344 North Main Street | Andover · MA 01810
(978) 416-0920 | www.civildci.com

CDCI File #: 20-10201
22 Montvale Street
Melrose, MA 02176

Civil Design Consultants, Inc. (CDCI) has prepared this information to address a Memorandum from the Department of Public Works, dated April 17, 2024, regarding the current design of the stormwater management system for the proposed dwelling located at 22 Montvale Street. In the Memorandum, Comment 2 states that *'while the draft Stormwater Handbook allows for a reduction in effective impervious cover if a rain barrel or cistern is sized to capture the 1-inch water quality volume, this only allows for the impervious areas to be deducted from Standard 3 (groundwater recharge) and Standard 4 (Pollutant Removal). It does not allow for removal from Standard 2 (peak flow attenuation). DPW therefore, will not approve this method as a way to attenuate peak flows. An alternative method to attenuate peak flows should be explored.'*

*Pre- and Post-Development HydroCAD modeling analysis without any stormwater management systems

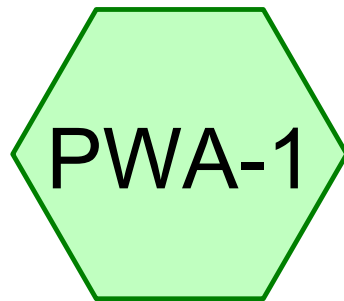
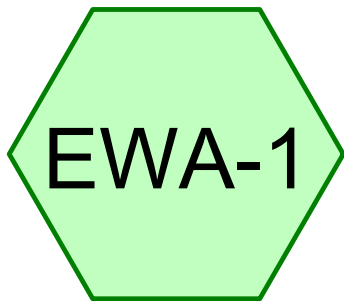
¹ See attached Exhibit 1 illustrating the pre- and post-development HydroCAD modeling peak flows (rounded to the hundredth decimal place) without any stormwater management systems to provide context of the de minimis increase in post-development peak flows.

According to Section 235-73.2D.(1)(a)(10) of the Zoning Ordinance of the City of Melrose, projects applying for the Slope Protection Special Permit are required to demonstrate that post-development run-off does not exceed pre-development run-off. The project proposes a minor increase of 1,238-SF of impervious area, associated with the rooftop, and stairs required to access the driveway. The additional proposed impervious area increases peak flows towards Montvale Street by 0.02-CFS in post-development for the 2-year, 10-year, and 25-year, and 0.01-CFS for the 100-year storm¹. Although the increase peak flows are considered de minimis, the Applicant proposes to install two (2) 550-gallon above-ground rain barrels, designed to capture and store runoff from the entire 1,360-SF rooftop area, while slowly releasing overflows, directed towards surrounding vegetation. The Drainage Memo submitted to the City, dated April 9, 2024, included one (1) rain barrel to mitigate peak flows to the tenth decimal place. The attached updated Drainage Memo, dated April 24, 2024, has been revised to expand the peak flow units to the hundredth decimal place, and as a result, an additional rain barrel has been added in order to attenuate peak flows to the hundredth decimal place.

To summarize, the Applicant understands the importance of mitigating any potential adverse effects as a result of the proposed development and is willing to take steps to minimize the impact of what we believe to be a de minimis increase in peak flows by installing rain barrels to capture and store rooftop runoff. As illustrated in Exhibits 3 and 4, the current and DRAFT Massachusetts Stormwater Handbook states that rain barrels can be used to attenuate peak flows and is recognized and encouraged by MassDEP and the City of Melrose as a Low Impact Development technique that provides the least amount of disturbance to the existing natural slopes.
